### **Response-to-Comments Table**

(Planning Application No. A/KC/511)

Planning Application No. A/KC/511 - Submission of Further Information

Responses to Comments – Departmental Comments

Example P1

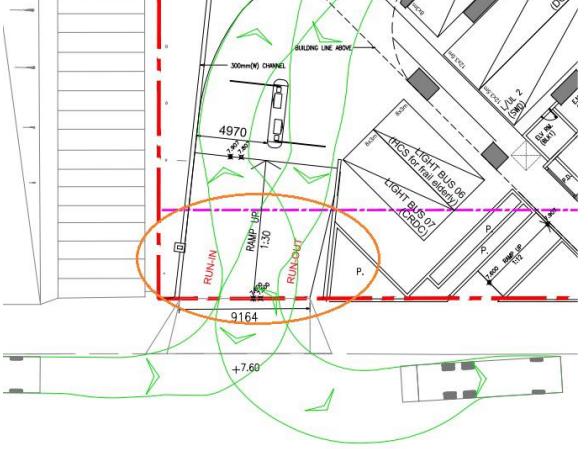
No.	Comments	Responses
	<p>(6) We are given to understand that the RCV size used in the swept path analysis is 2.5m x 11m. The RCP should be designed to allow a RCV or hook-lift truck of 3m(W) x 11m(L) to make a 3-point-turn and park therein without restriction, with minimum clearance of 500mm between the swept path of RCV and building structures. The swept path analysis should be updated using the actual dimensions and weight parameters of the RCV currently deployed for our further comments.</p> <p>(7) From a vehicular access perspective, Lai King Hill Road is a downhill dual-lane road with double white lines separating traffic in both directions. Additionally, it is a restricted zone with double yellow lines along the road. Therefore, entering the RCP with a tail-in approach should be avoided, as it may cause congestion and accidents given the geographical limitations and road regulations.</p> <p>(8) The entrance point at the proposed RCP near Lai King Hill Road should be sufficiently wide to allow the RCV to turn in and out of the estate without encroaching on the opposite lane (Example P1 refers). Furthermore, if a gate is installed at the entrance, its operation must also avoid requiring the use of the opposite lane (Example P2 refers).</p>	<p>The swept path analysis of 3m(W) x 11m(L) RCV with 500mm clearance is provided in <b>Figure SK-023_SP2</b> of this submission.</p> <p>Please be advised that the vehicular access of the Application Site have been designed that all vehicles will be entering and leaving the site with a “head-in and head-out” approach, and all vehicles could manoeuvre in and out of the application site without encroaching on the opposite lane. Please refer to the attached <b>Figure SK-023_SP3</b> for the swept path analysis of 3m(W) x 11m(L) RCV with 500mm clearance at the vehicular access.</p> <p>Please be advised that the vehicular access of the Application Site have been designed that all vehicles will be entering and leaving the site with a “head-in and head-out” approach, and all vehicles could manoeuvre in and out of the application site without encroaching on the opposite lane.</p>

SK-023\_SP2

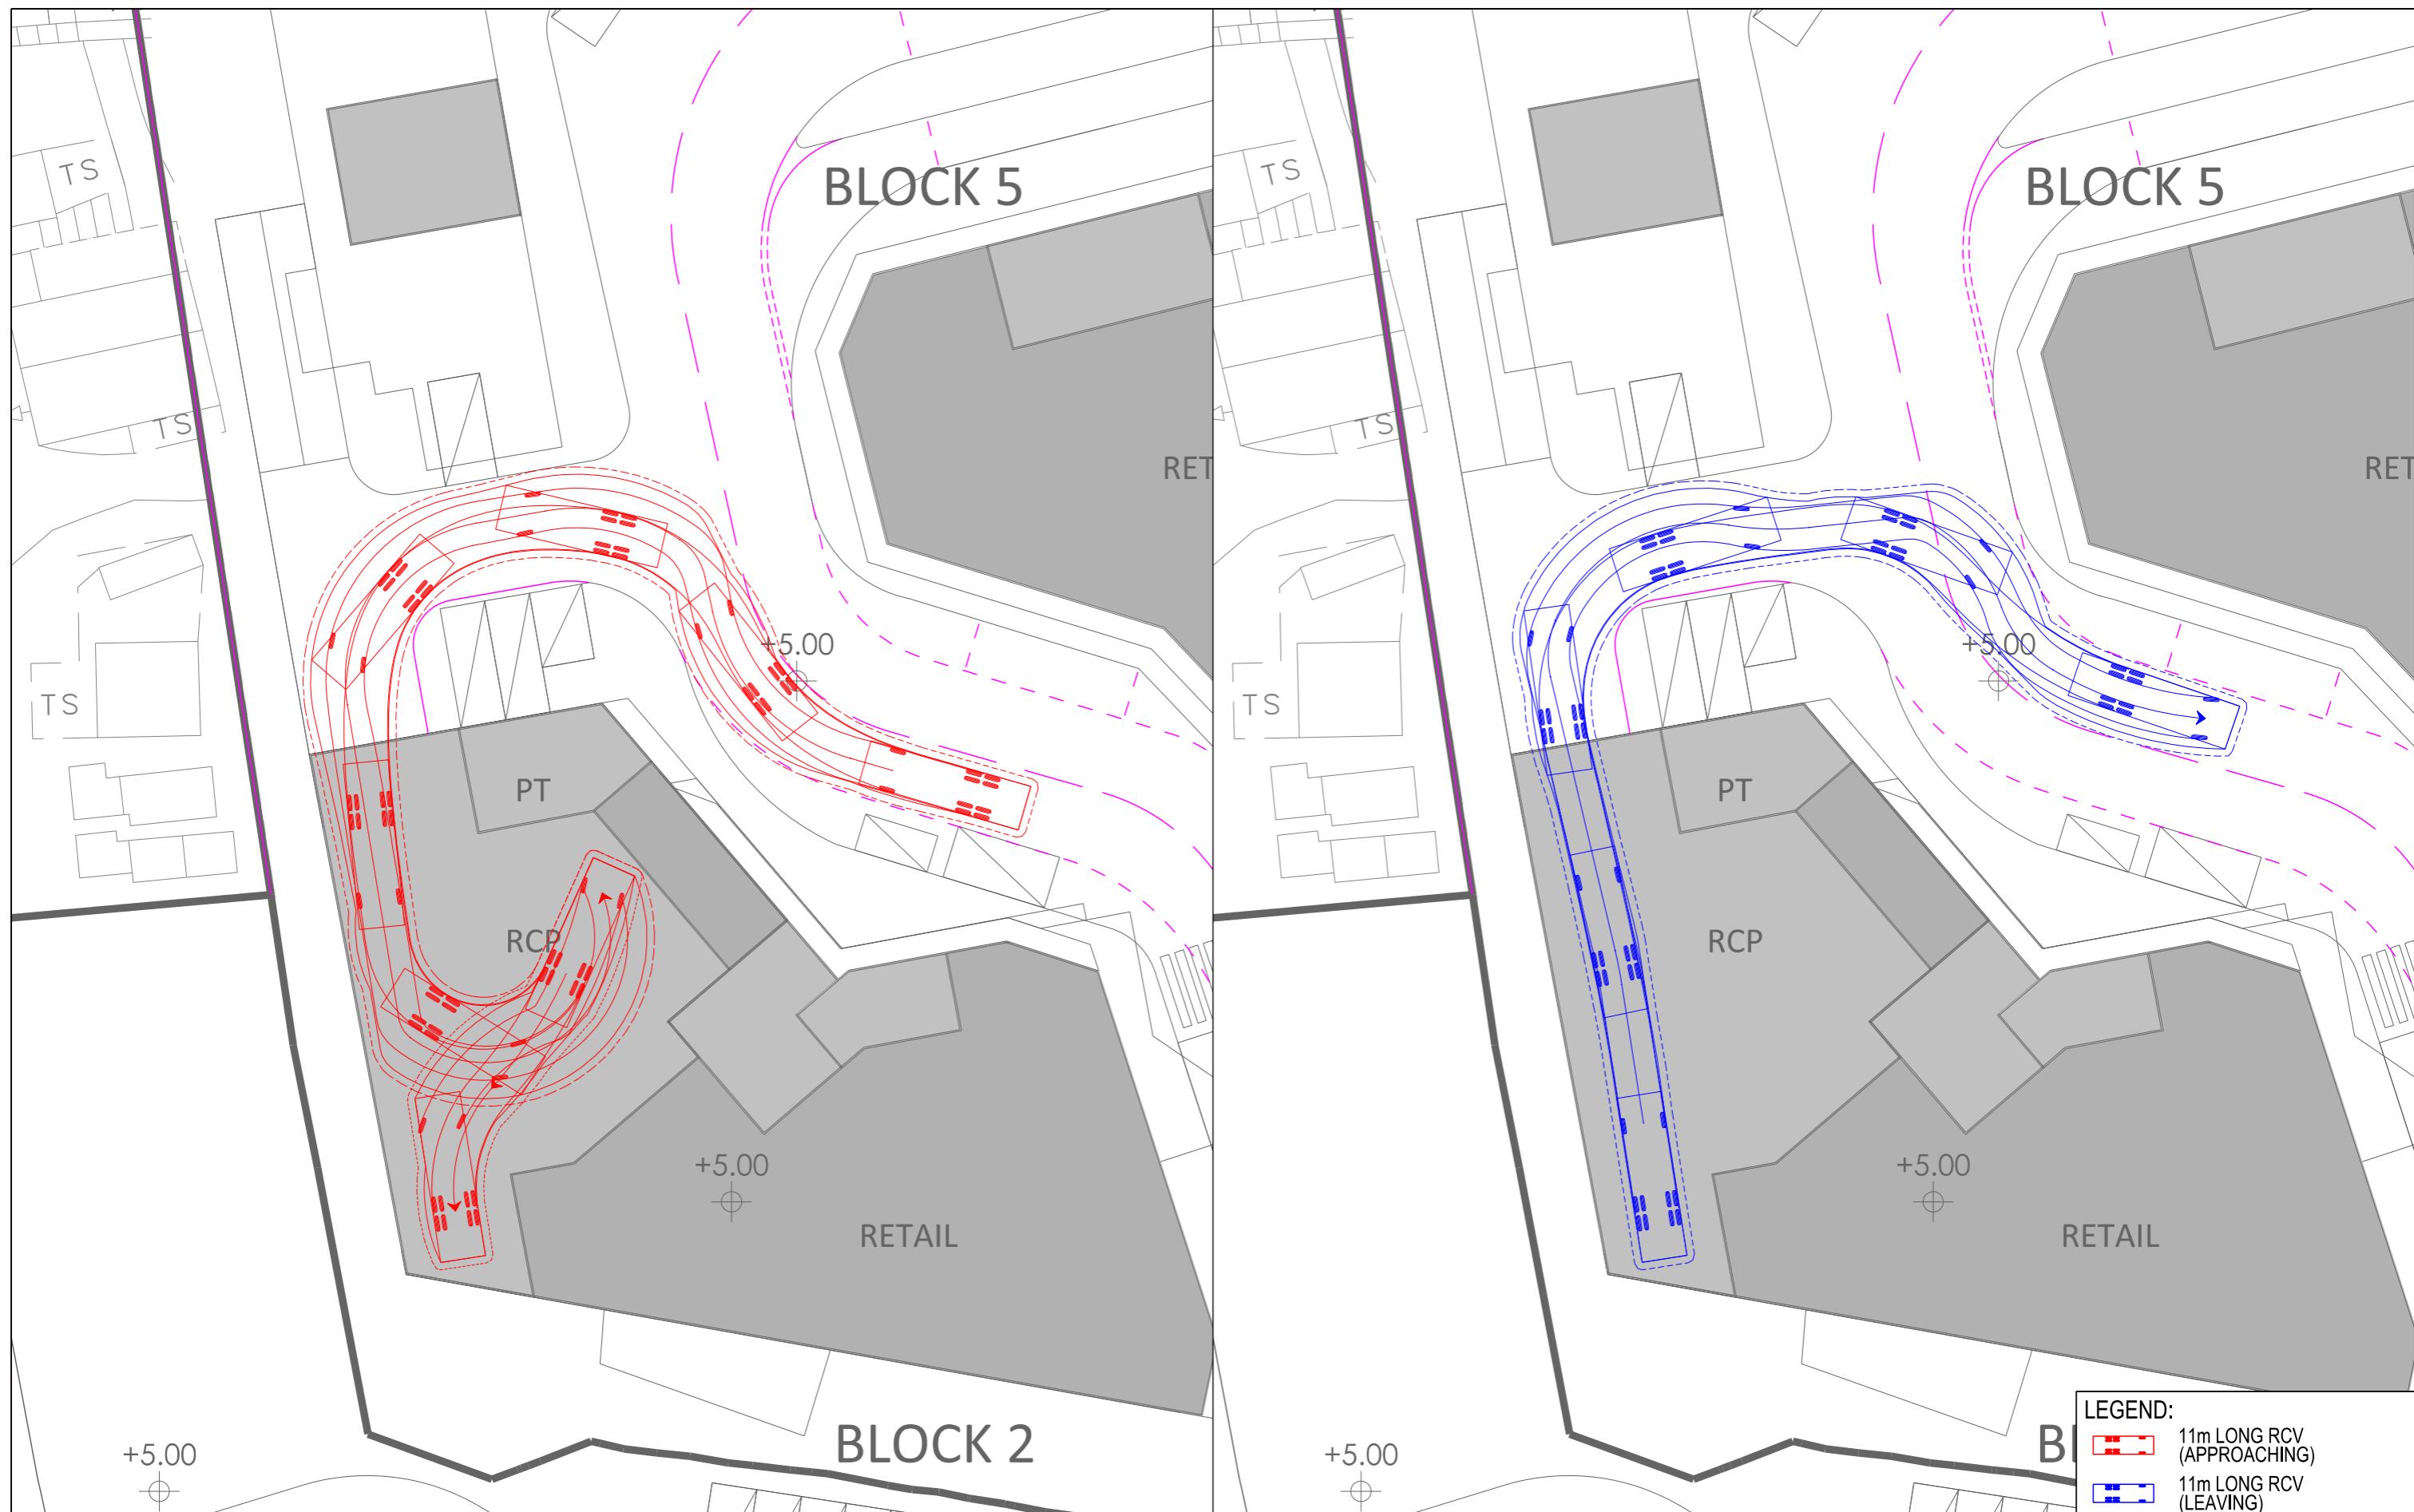
No.	Comments	Responses
	 <p>Example P2</p> <p>(9) A Head-in and head-out approach should be adopted for the RCV entering, parking and leaving the RCP. However, if adequate turning space is available to perform a 3-point turn without restrictions in front of the RCP, a tail-in and head-out approach may also be acceptable.</p> <p>(10) Please provide the dimensions of the access road, ensuring compliance with the stipulated requirements in the section 3.3.1(b) of the Handbook: "All access roads to and from the loading area should preferably be 4.0m wide but no less than 3.5m. There should be ingress and egress with a run-in over the pavement in connection with the roadway."</p> <p>(11) Kindly advise whether a minimum clearance of 0.5 meters between the swept path and any obstacles, such as walls or facilities, could be provided to ensure safe access and maneuverability for the RCV within the RCP.</p> <p>(12) The site area designated as the Junk Collection Point (JCP) should be an outdoor space without headroom restrictions. A 3-point turn without restrictions should also be adopted.</p>	<p>Noted.</p> <p>Please be advised that dimensions of the internal access road complies all statutory requirements. Please refer to the attached <b>Figure SK-022</b> for the dimension markups of the internal access road close to Lai King Hill Road.</p> <p>The swept path analysis of 3m(W) x 11m(L) RCV with 500mm clearance is provided in <b>Figure SK-023_SP2</b> of this submission.</p> <p>Noted.</p>

Job Title	Fresh S16 for Kau Wah Keng CDA (PR6.5)			SK-023_SP3
Date	Scale	Drawing Title		
19JAN26	1:400@A3	SWEPT PATH ANALYSIS FOR 11m LONG RCV		
Drawn WLAC	Job No. 299277-02			ARUP

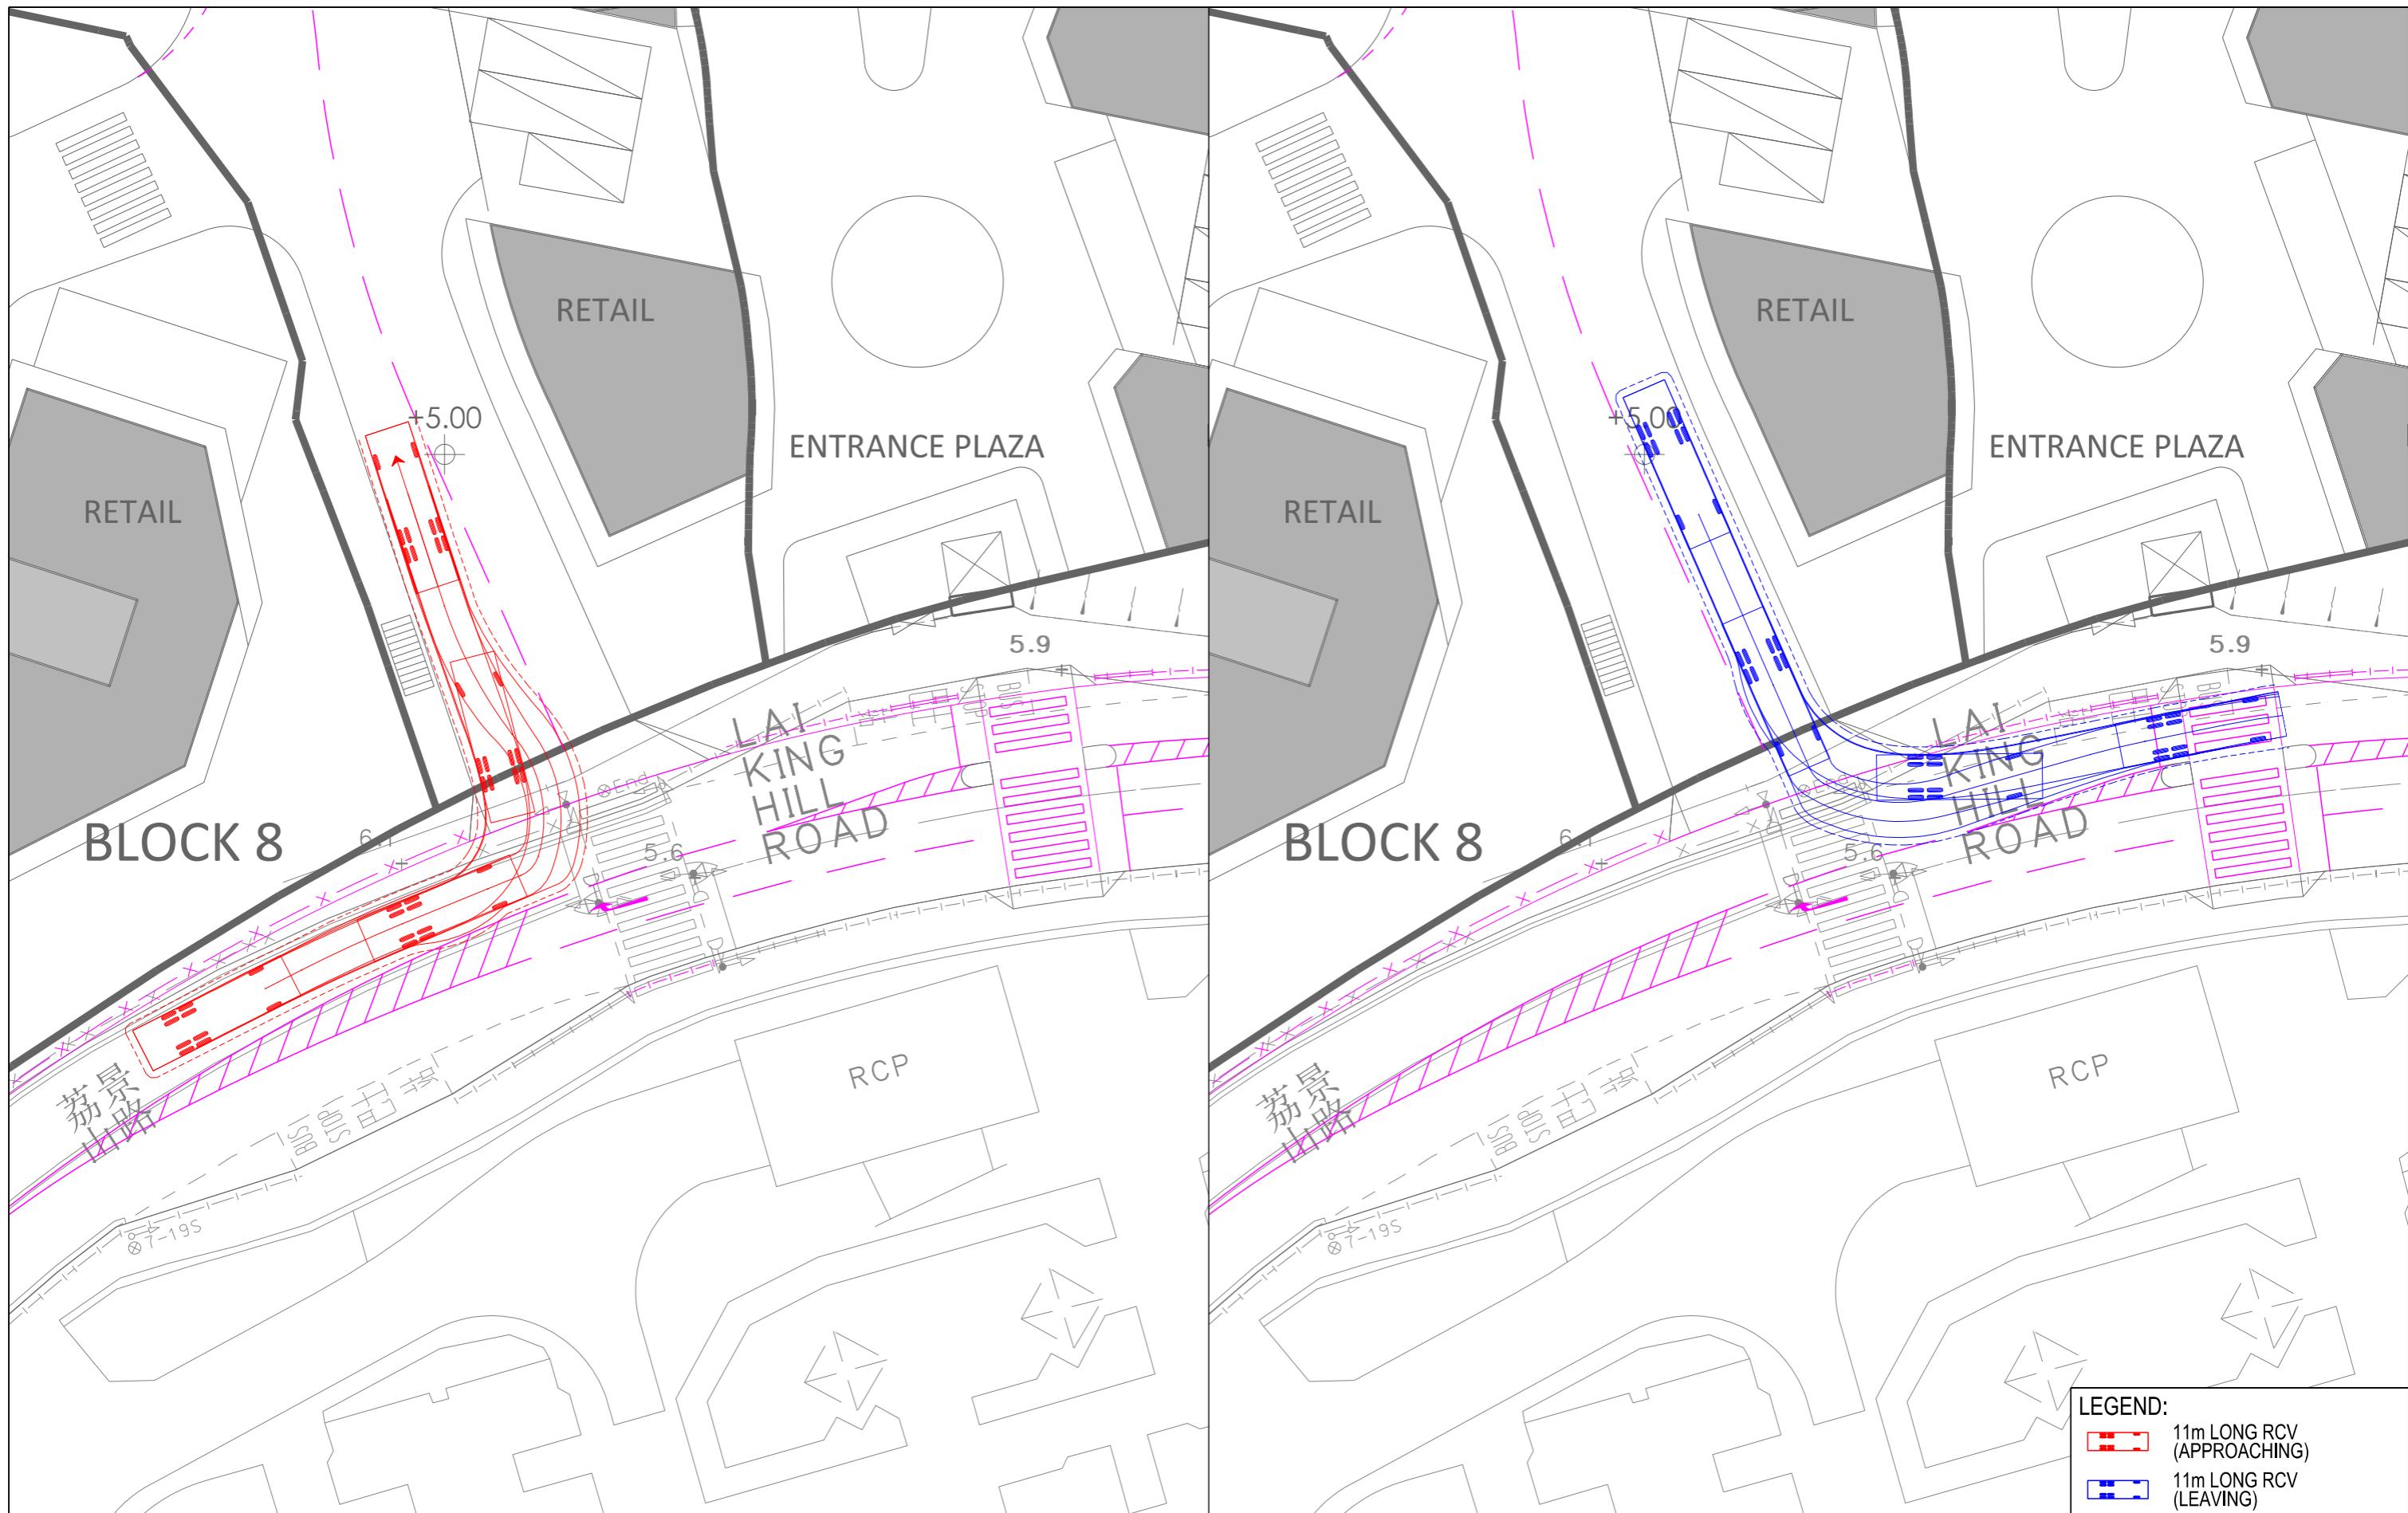
No.	Comments	Responses
	<p>(13) As stated in the Handbook, the headroom for HLT should not be less than 5.5m if it is an indoor parking and operational space.</p> <p>(14) Please confirm whether strict compliance with all applicable traffic regulations and vehicle maneuverability standards for the public access road serving the development site is being observed. For instance, RCVs must not encroach into the opposite lane when entering or departing from the RCP.</p> <p>(15) Please confirm whether the proposed refuse collection operations will maintain strict compliance with all applicable emergency vehicular access (EVA) regulations.</p> <p>(16) Please confirm strict compliance with all requirements specified in the Handbook, especially section 3.3.1(a), (b), (c), (i) and (j).</p>	<p>Noted.</p> <p>Please be advised that the vehicular access of the Application Site and the external roadworks have been designed in compliances of the TPDM requirement, and have been circulated to TD for review and they have no adverse comment for the proposed design.</p> <p>Please be advised that RCVs will not encroach on the opposite lane when entering or departing the application site. Please refer to attached <b>Figure SK-023_SP3</b> for the swept path analysis of 3m(W) x 11m(L) RCV with 500mm clearance at the vehicular access.</p> <p>Compliance confirmed.</p>
